**AMENDMENTS TO THE DRAWINGS**

**- R E M A R K S -**

FIG-1

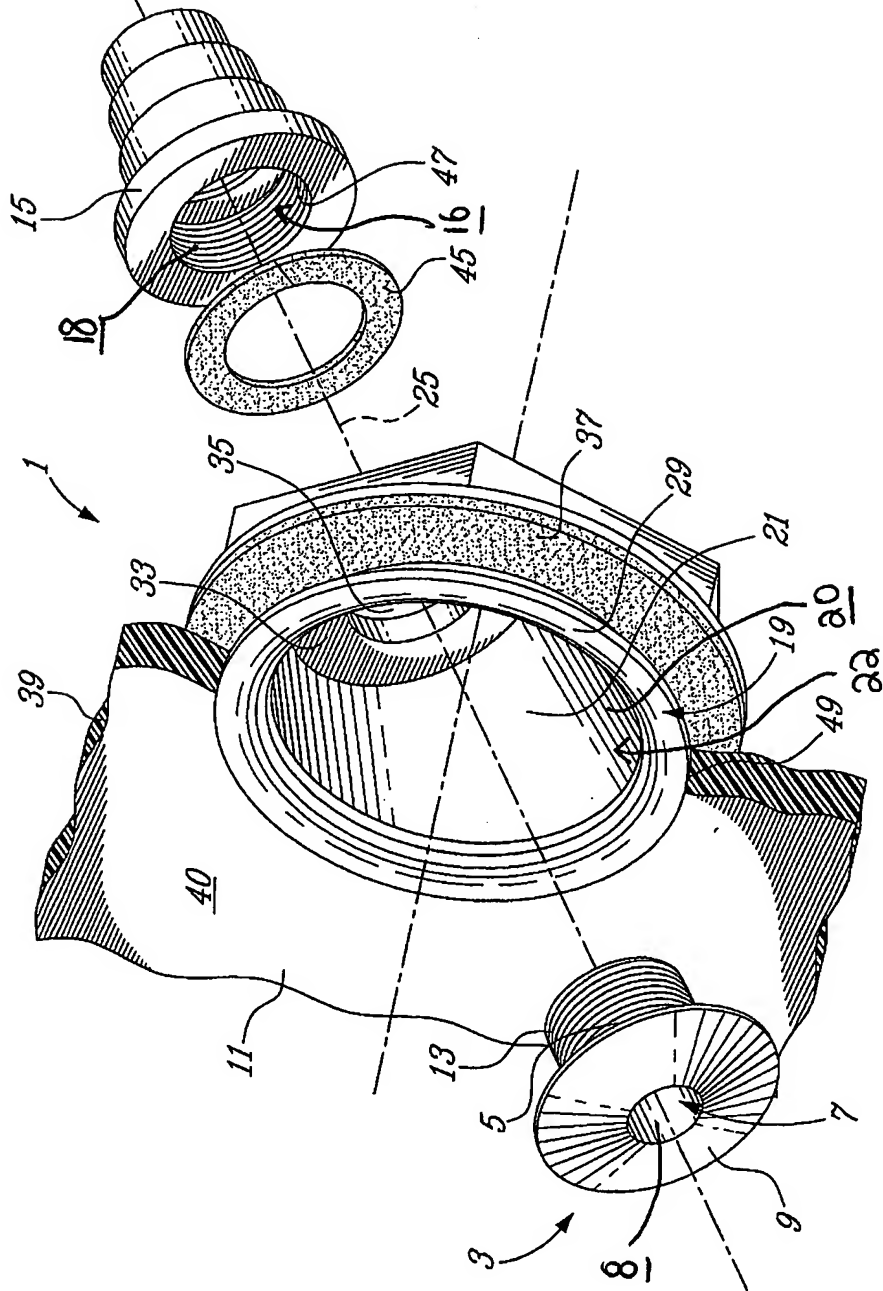
In Figure 1, the reference numerals 8, 16, 18, 20, and 22 have been added to identify the apertures 8, at opposed ends of the micro jet 3, the port 16 in the connector 15 with apertures 18 at opposed ends, and the peripheral wall 20 of the holding cup 19 which defines a cavity 22. Similarly, in Figure 2, the reference numerals 8, 16, 18, and 20 have been added to identify the same components. These components were already represented in Figures 1 and 2 and no new matter has been added.
